NUREG-1790/Docket 70-3103
Public Comment: Draft Environmental Impact Statement for the Uranium Enrichment Facility Proposed by Louisiana Energy Services for Lea County, NM

The Staff of the New Mexico Attorney General's Office ("AGO") is submitting these comments to the Draft Environmental Impact Statement for the Proposed National Enrichment Facility in Lea County, New Mexico ("EIS") to the U.S. Nuclear Regulatory Agency ("NRC"). In the first section, we will discuss our general, overall comments. In the second section, we will provide specific, line-by-line comments.

Figure E-8 Average 24-Hour Concentrations of Pollutants in Extreme Winds from the West-Southwest

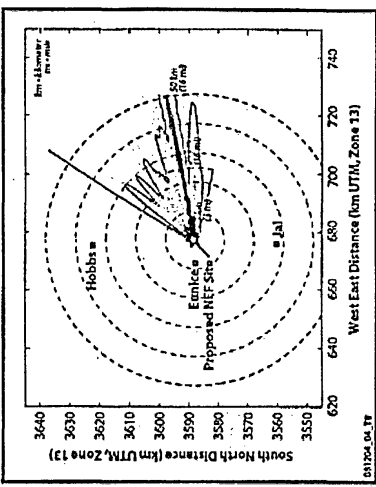
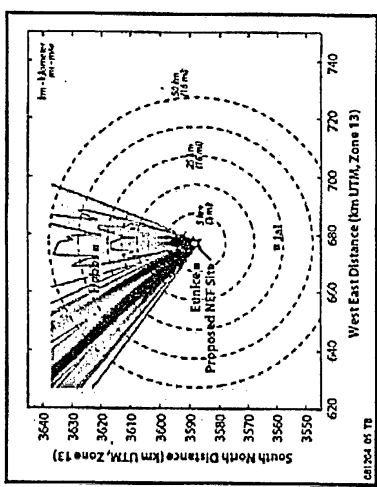
I believe the emissions from the proposed Les enrichment plant will be deposited into the loose topsoil we have in this area. Seasonal winds from the south, some can be in excess of 50mph, will eventually blow the contaminated soil north over Hobbs.

This poses health risks for everyone between that plant and Hobbs. That is over 30,000 people. I believe that if that plant goes into operation, the state of New Mexico and the federal government should be financially responsible for all new cancer cases in contaminate field: Hobbs and Eunice and surrounding areas.
